## TABLE OF CONTENTS

Following NRC guidance in Regulatory Guide (RG) 1.206, “Combined License Applications for Nuclear Power Plants (LWR-Edition),” and in RG 1.208, “A Performance-Based Approach to Define Site-Specific Earthquake Ground Motion,” the applicant defined the following four zones around the STP site and conducted investigations within those zones:

FSAR Section 2.5S.1 of the STP COL application includes geologic information that the applicant collected during regional and site investigations. This technical information results primarily from surface and subsurface geologic, seismic, geophysical, and geotechnical investigations performed in progressively greater detail closer to the site and within each of four circumscribed areas corresponding to site region, site vicinity, site area, and site location, as previously defined. The primary purposes for conducting these investigations are to determine the geologic and seismic suitability of the site, to provide the bases for the plant design, and to determine whether there is significant new tectonic or ground motion information that could impact the seismic design bases, as determined by a PSHA. The applicant's basic geo

Figure 2.5.4-7. Site-Specific Sand Shear Modulus Curves Based on RCTS Testing (FSAR Figure 2.5S.4-62)

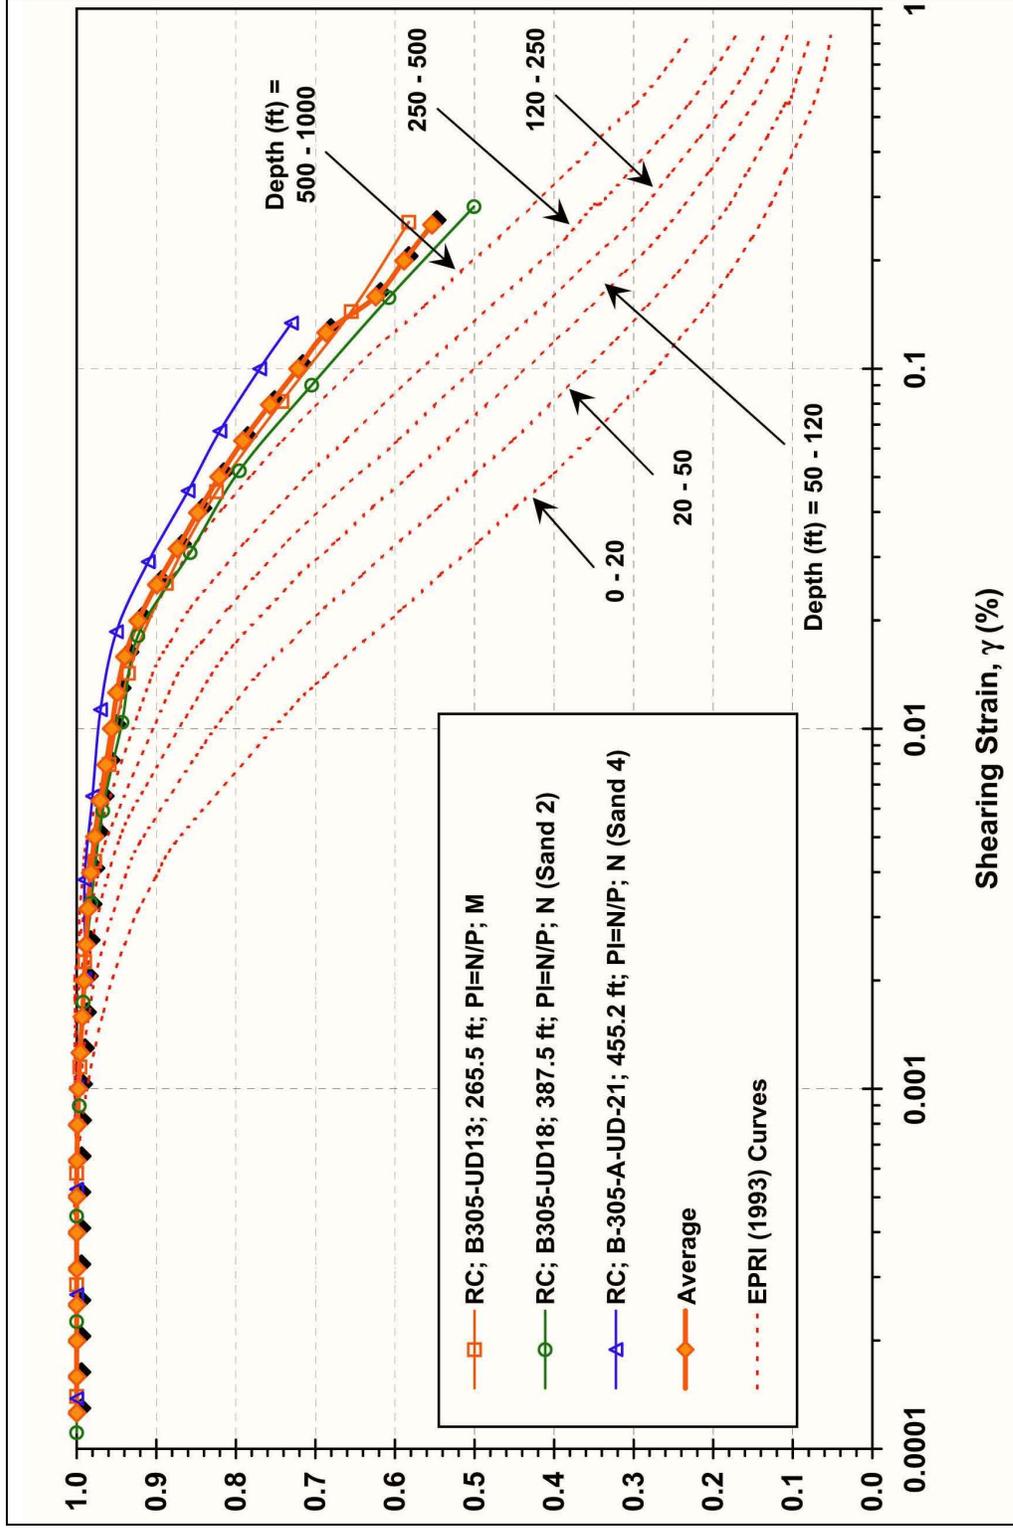
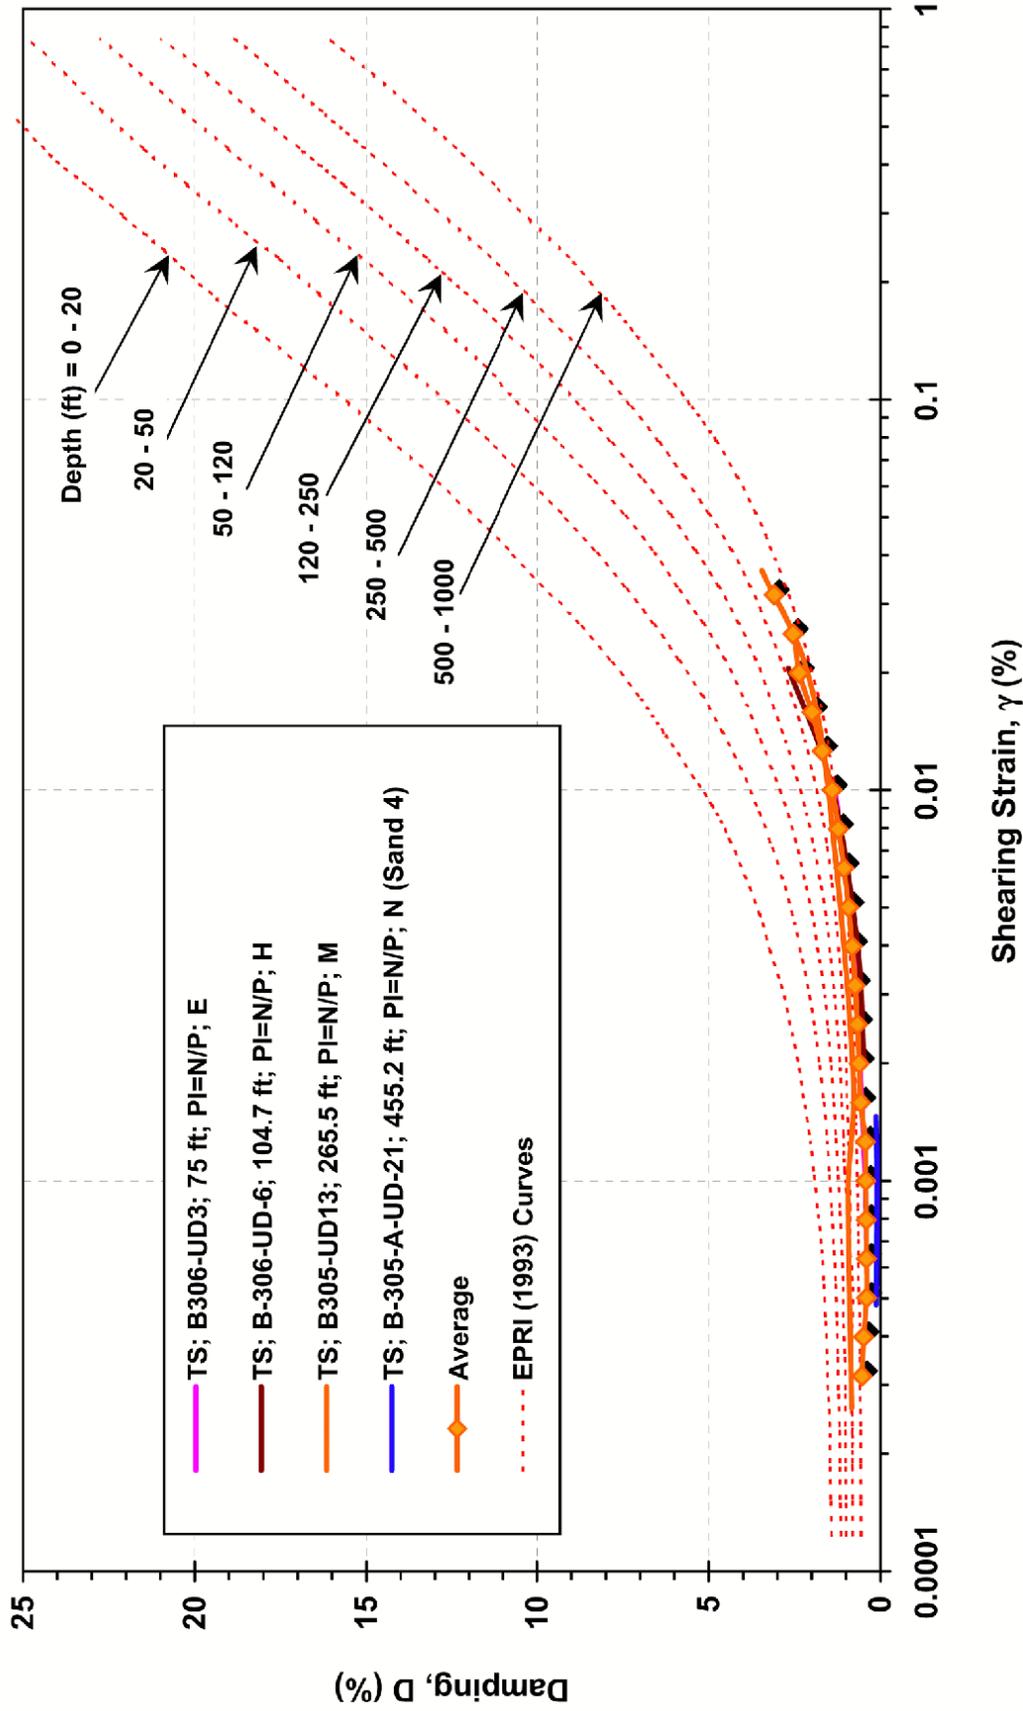
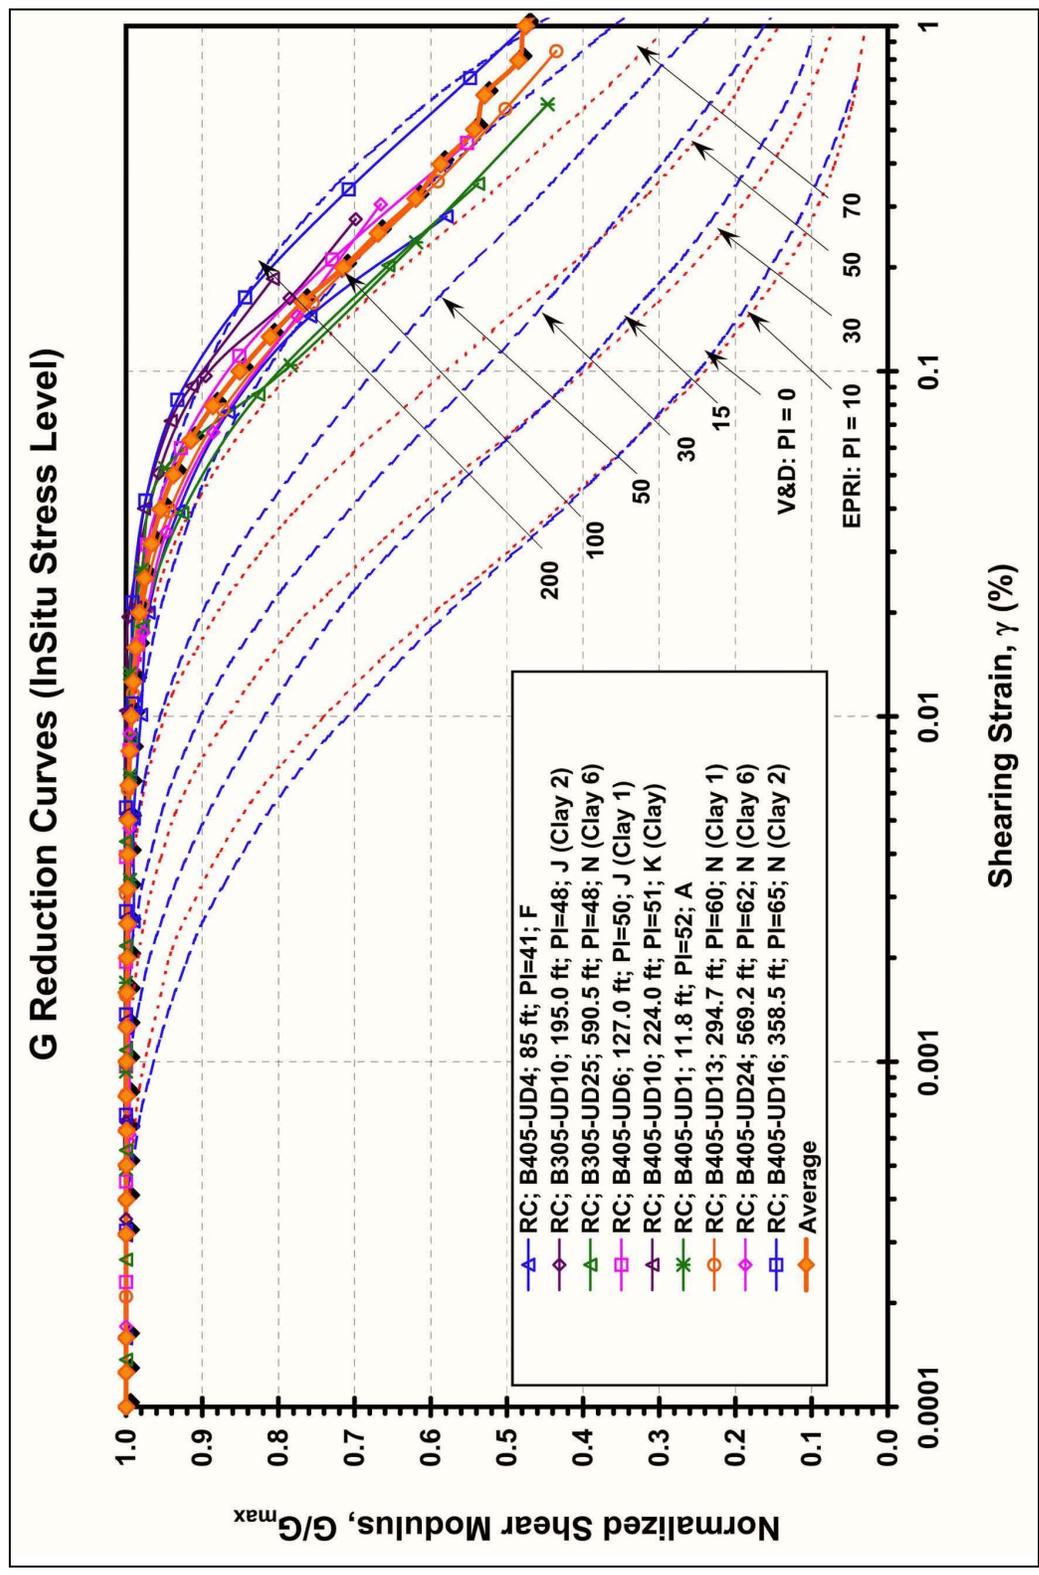
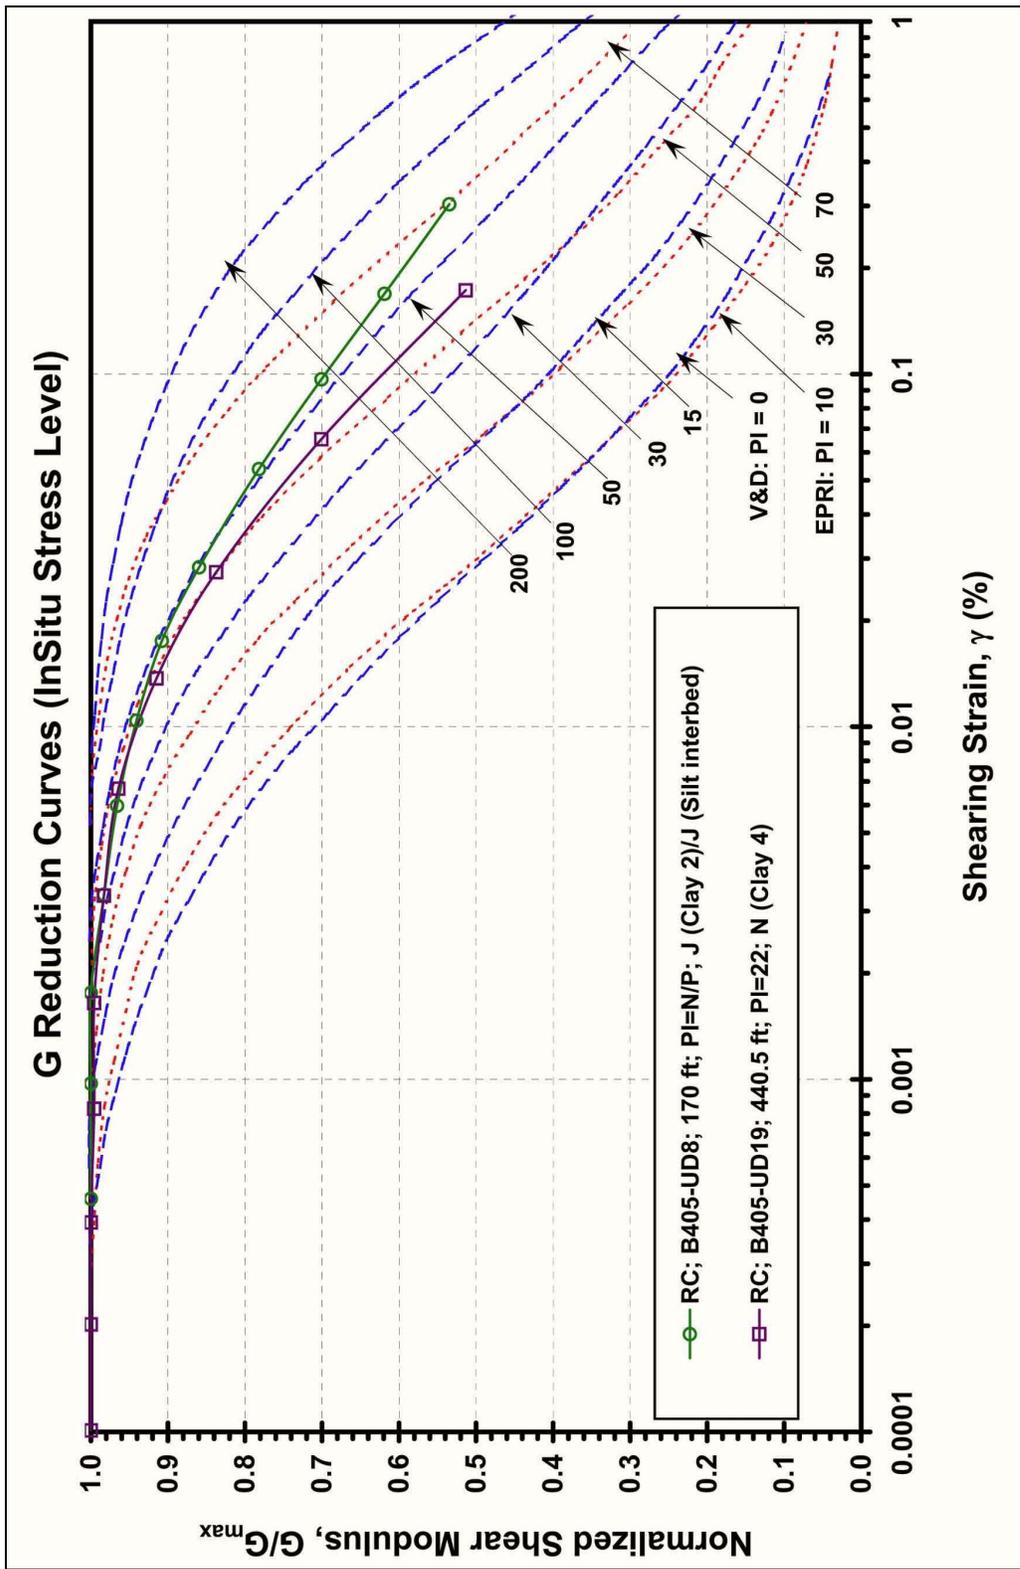
The applicant's response to RAI 02.05.02-17 dated July 2, 2008 (ML081890239), revises the COL application to include additional RCTS testing in FSAR Subsection 2.5.4.7, which increases the total number of RCTS tests from five to sixteen. The applicant also presents in FSAR Figures 2.5S.4-62 through 2.5S.4-68 site-specific shear modulus and damping ratio curves developed for each stratum down to a depth of approximately 182.8 m (600 ft). The applicant demonstrates that the selected shear modulus and damping ratio versus strain relationships from the literature closely match the site-specific developed curves. Because the literature-based curves were carried out at higher strain levels than the site-specific curves, the applicant used the literature-based curves to calculate the GMRS. SER Figures 2.5.4-7 and 2.5.4-8 (FSAR Figures 2.5S.4-62 and 2.5S.4-66) compare the site-specific shear modulus and damping ratio curves performed on all sand stratum to the EPRI curves, respectively.

The staff reviewed the applicant's RCTS results and the comparisons to the literature-based curves presented in FSAR Figures 2.5S.4-62 through 2.5S.4-68. Except for the deep cohesionless soils in FSAR Figure 2.5S.4-63, the staff agreed with the applicant that the site-specific curves are bounded by the literature-based curves and selected the literature-based curves that best define the trend of the site-specific curves for use in computing the GMRS with one exception: the deep cohesionless soils in SER Figure 2.5.4-1 display a stiffer response than the EPRI curves. However, considering that the EPRI curve selected to represent the deep sand strata is not significantly different from the site-specific curves out to a strain of 0.1 percent, and the logarithmic mean maximum strain profiles in SER Figure 2.5.4-11 (FSAR Figure 2.5S.2-47) are typically significantly less than 0.1 percent strain, the staff concluded that the selected literature-based curves track well with the site-specific curves and are appropriate for determining the GMRS. Finally, the staff concluded that the characterization of the dynamic properties of the in situ materials is complete, therefore, RAI 02.05.02-17 is closed.

Figure 2.5.4-12. Plot of All Data Showing Plan Locations in All Strata of Soils Exhibiting a Factor of Safety Less Than 1.4 for Three Methods of Investigation (RAI 02.05.04-28 Response Figure 50)

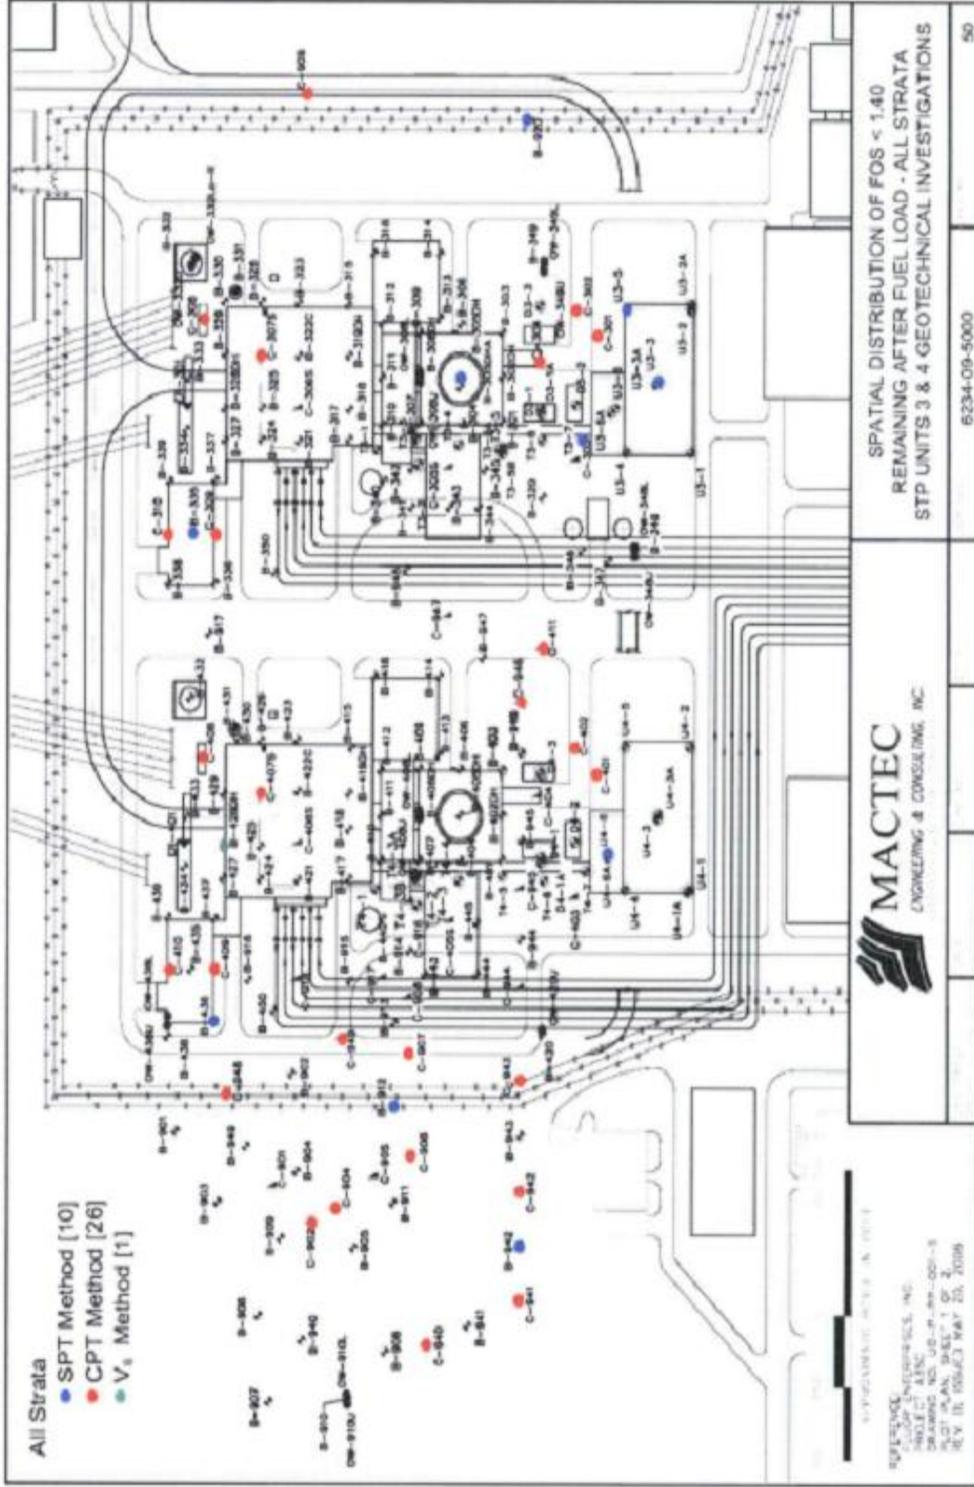
encountered in the borings. The applicant notes that an evaluation of the histograms does not reveal a definitive stratum possessing a majority of factor of safety values of less than 1.4.

The applicant concludes that the Beaumont formation is geologically old, and the incorporation of a correction factor for age will likely increase factors of safety above the 1.4 threshold. The applicant further concludes that although quantitative data to support an age correction factor are lacking, the age of the deposit is sometimes accounted for by omitting the correction factor for stress (Ks factor). Using a simple calculation, the applicant demonstrates that omitting the Ks factor is substantial enough to increase computed factors of safety above 1.4. The staff finds this acceptable. Therefore RAI 02.05.04-5 and RAI 02.05.04-28 are closed.
